**Building Permit Application**  
Howard County Maryland  
Department of Inspections, Licenses and Permits  
3430 Court House Drive  
Permits: 410-313-2455  
www.howardcountymd.gov

Description of Work: In stock 1 x 1000 underground propane tank and gas line to side of house

**From:** Bernard, Dana  
**Sent:** Tuesday, May 07, 2019 10:41 AM  
**To:** 'gphillips@mred.us'  
**Cc:** Najib Roshan (roshannj@aol.com); 'rliff@carusohomes.com'  
**Subject:** RE: Simpson Road

| ONSITE SEWAGE DISPOSAL SYSTEM DESIGN PLAN |                       |

5 Bedrooms

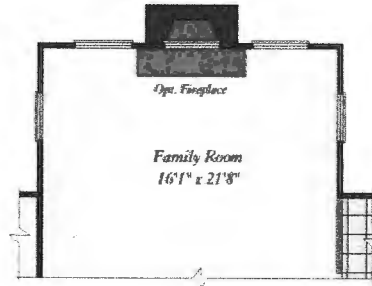
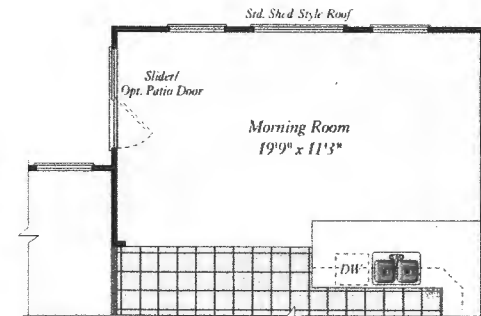
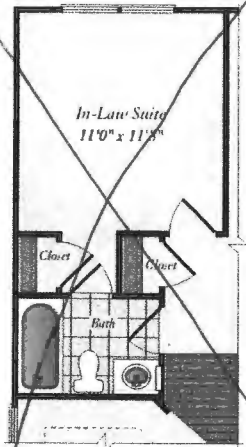
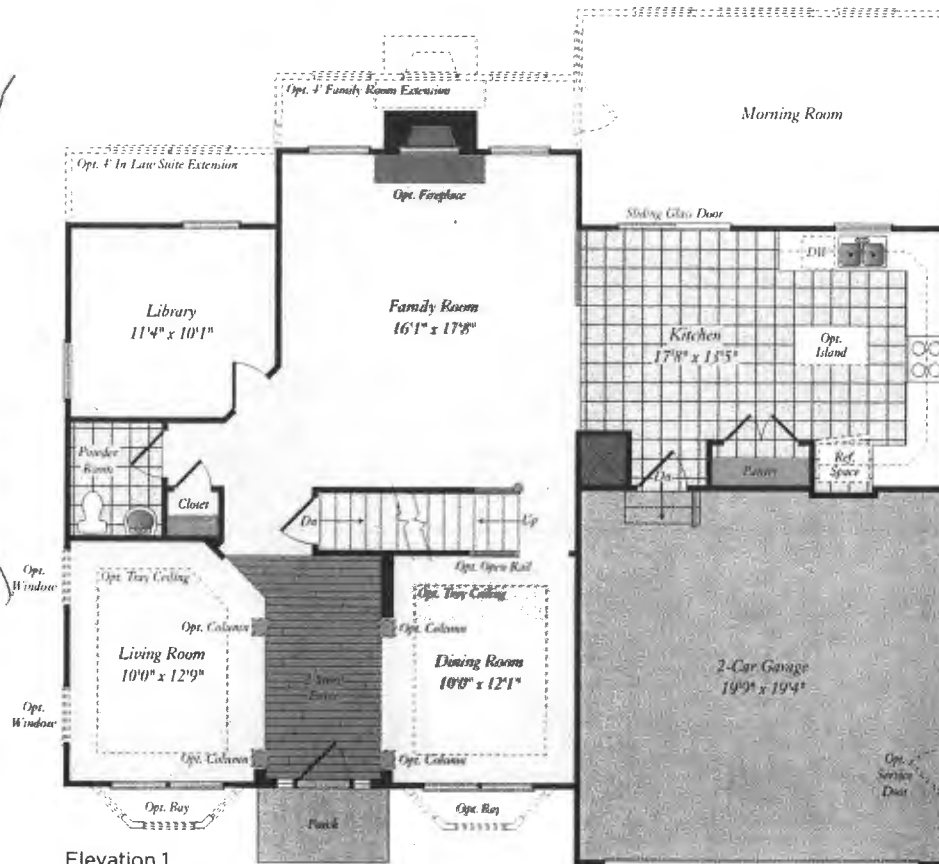
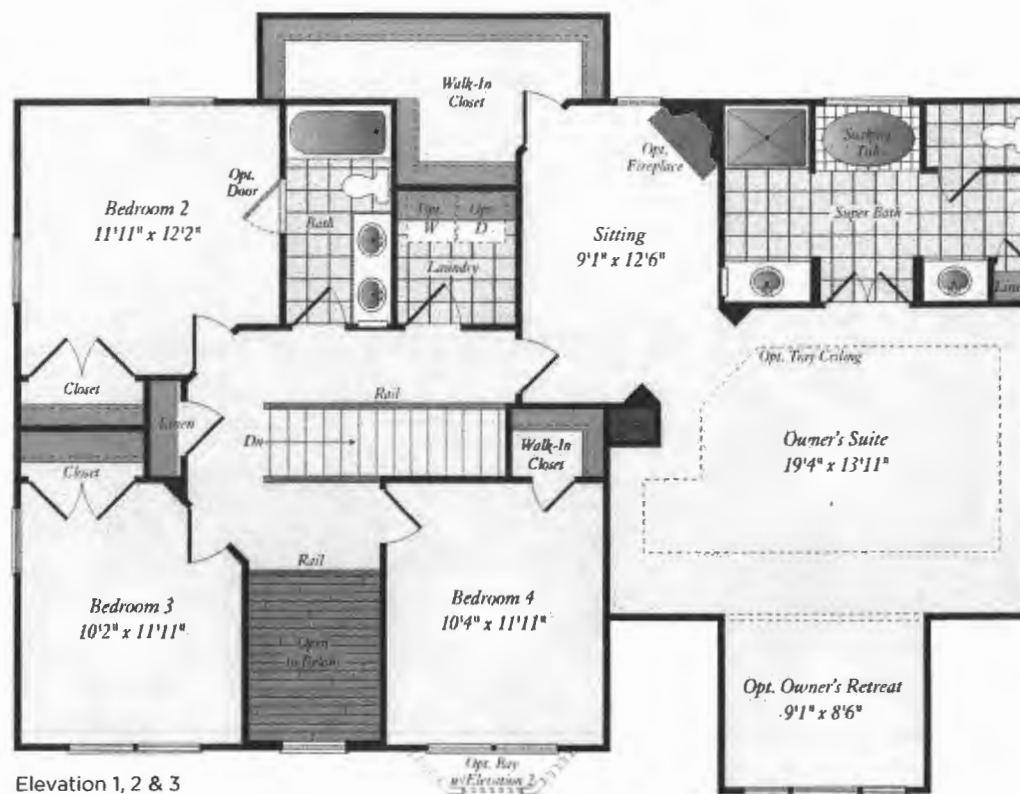
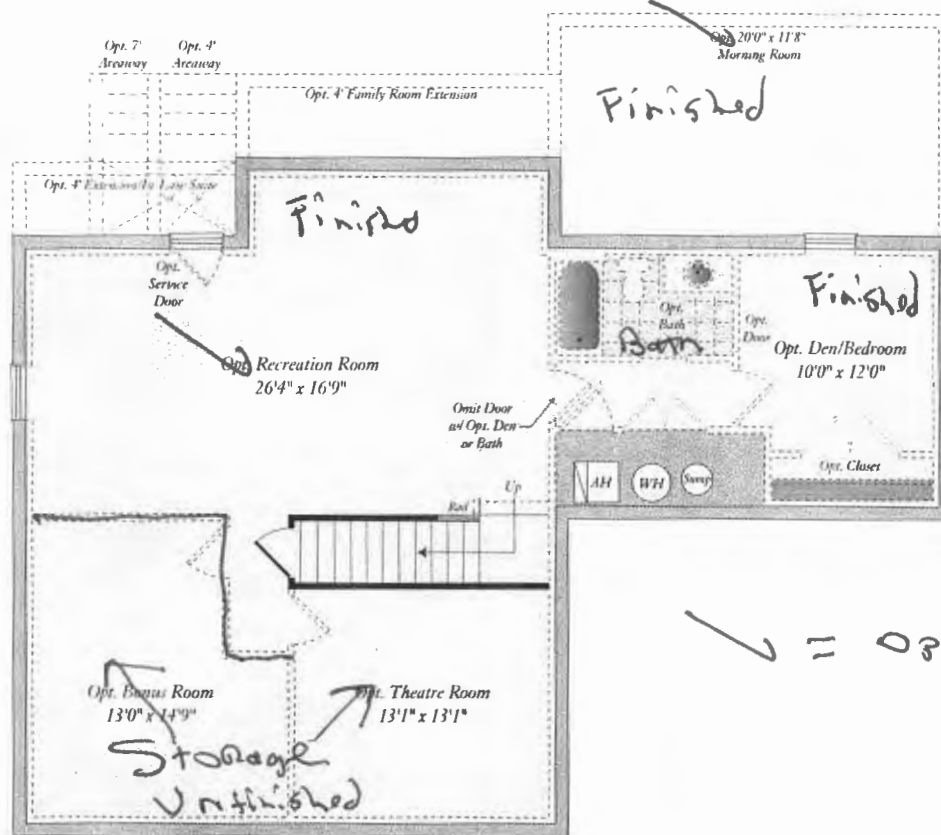
Everything looks good on the plan. However, the floor plans submitted for this property shows 5 bedrooms. The septic calculations must reflect the minimum number of bedrooms proposed. Only a friendly reminder regarding the gravity flow of 1%. On paper systems appear to fit with no problem, however if your plan does not work in the field we will have to go back to the drawing board and submit a new OSDS plan.

**McCoy Property - Lots 1 & 2**  
RESUBDIVISION OF LOT 1, CHERRY BRAE (PLAT # 5887)  
11965 SIMPSON ROAD, CLARKEVILLE, MD 21029

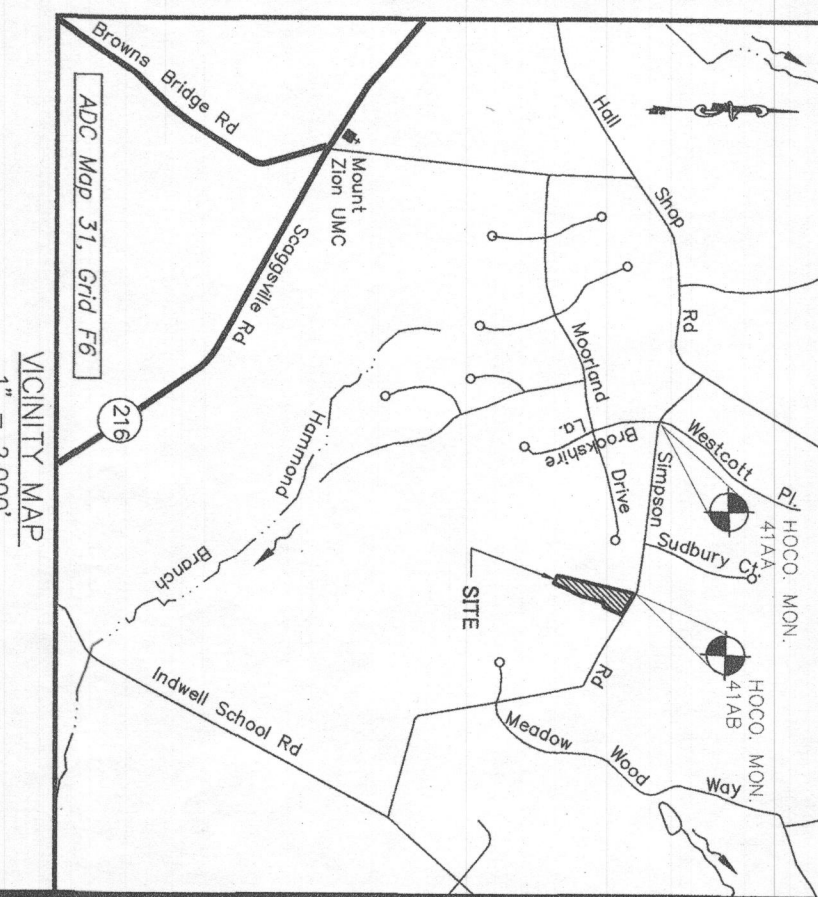
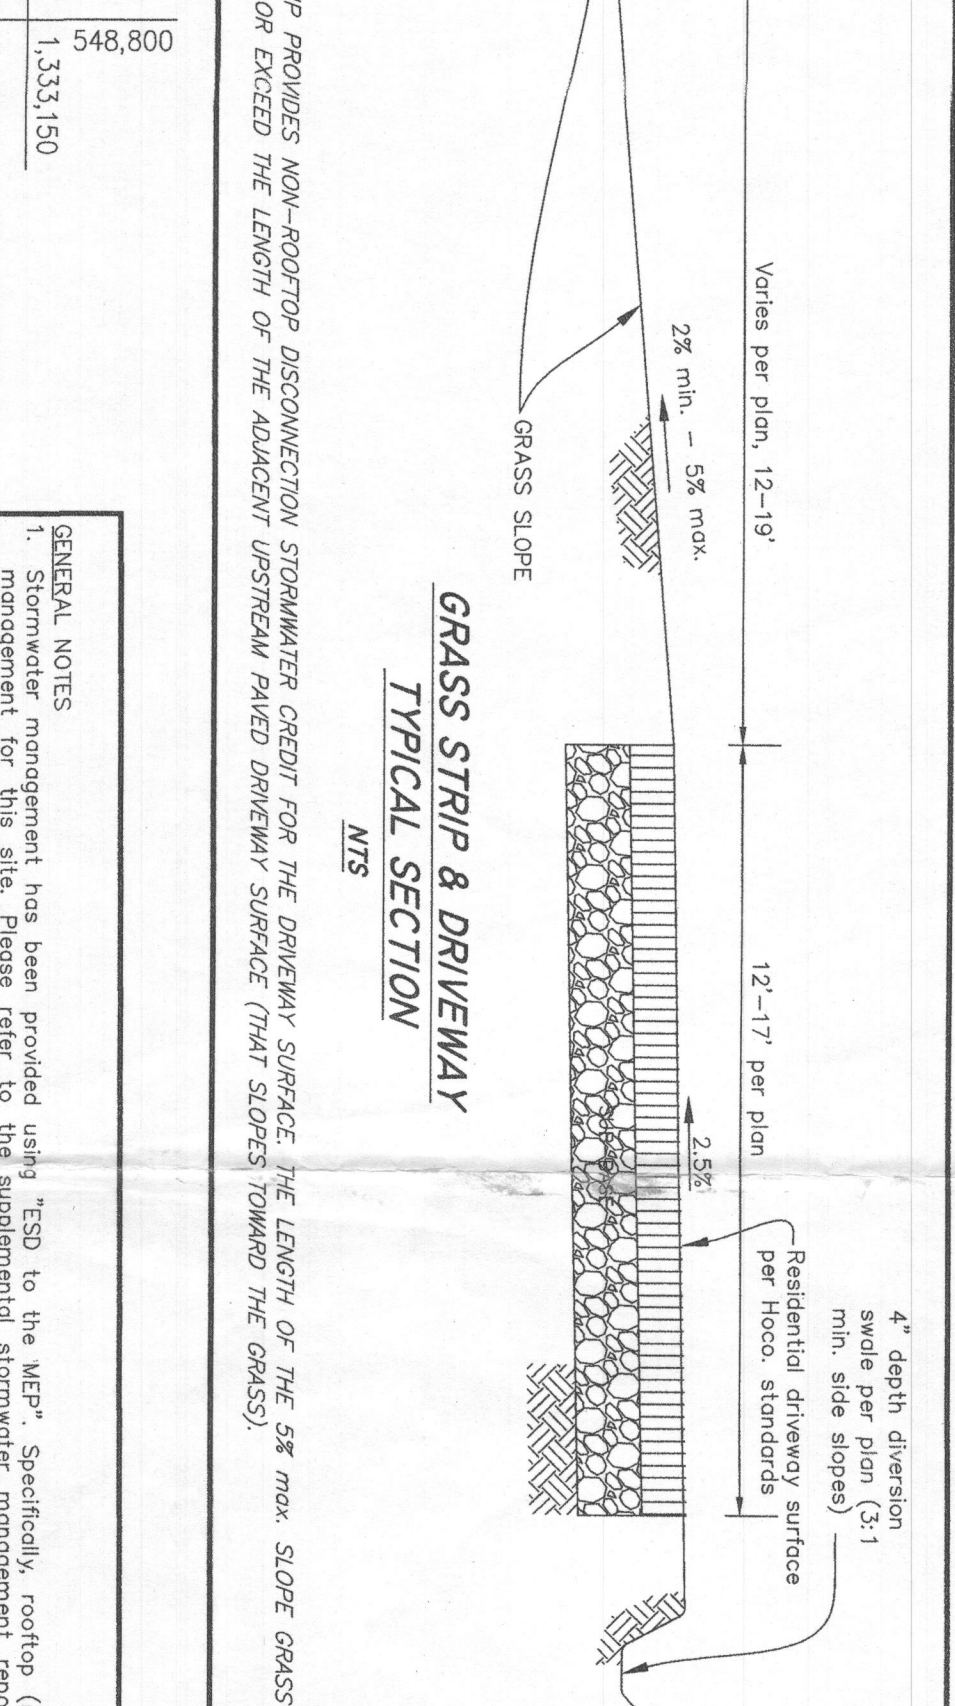
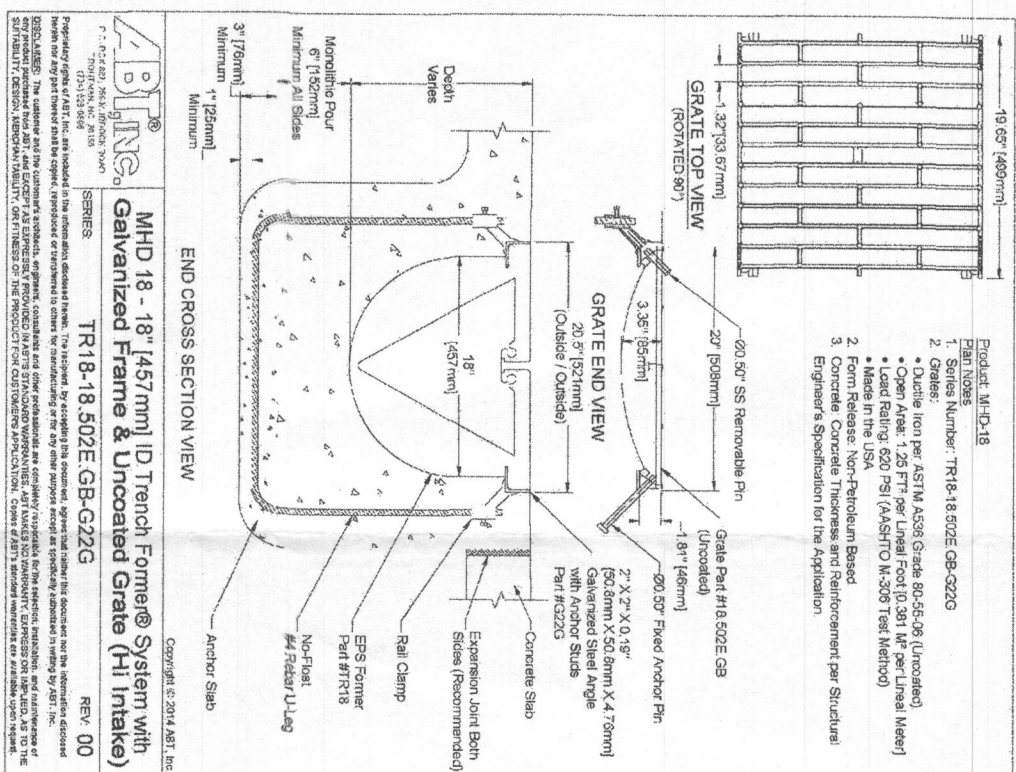
| SWM_PLAN_sht 1 of 2.pdf      | DED-PMT | Please make this sheet 1 of 1 as the SSD sheet does not need to be a part of this set. Add F-18-103 to the lower right hand corner of the sheet.  | 07/11/2018 | Phil Thompson |

| SWM_PLAN_sht 1 of 2.pdf | DED-PMT | Please revise as the SSD analysis is to be an exhibit and not part of the supplemental plan.   | 07/11/2018 | Phil Thompson |
| SWM_PLAN_sht 1 of 2.pdf | DED-PMT | Please provide a completed SWM Practice Chart with addresses.  | 07/11/2018 | Phil Thompson |
| SWM_PLAN_sht 1 of 2.pdf | DED-PMT | On sheet 1, please provide a Work Zone Traffic Control Plan for the connections to the public road in accordance with the Department of Public Works, Bureau of Engineering, Traffic Engineering Division requirements.  | 07/11/2018 | Phil Thompson |
| SWM_PLAN_sht 1 of 2.pdf | DED-PMT | On sheet 1, please provide details of non-standard structures.   | 07/11/2018 | Phil Thompson |
| SWM_PLAN_sht 1 of 2.pdf | DED-PMT | Please specify driveway apron detail reference.  | 07/11/2018 | Phil Thompson |
| SWM_PLAN_sht 1 of 2.pdf | DED-PMT | Please label areas as N-1 Disconnection of Rooftop Runoff and N-2 Disconnection of Non-Rooftop Runoff.   | 07/11/2018 | Phil Thompson |
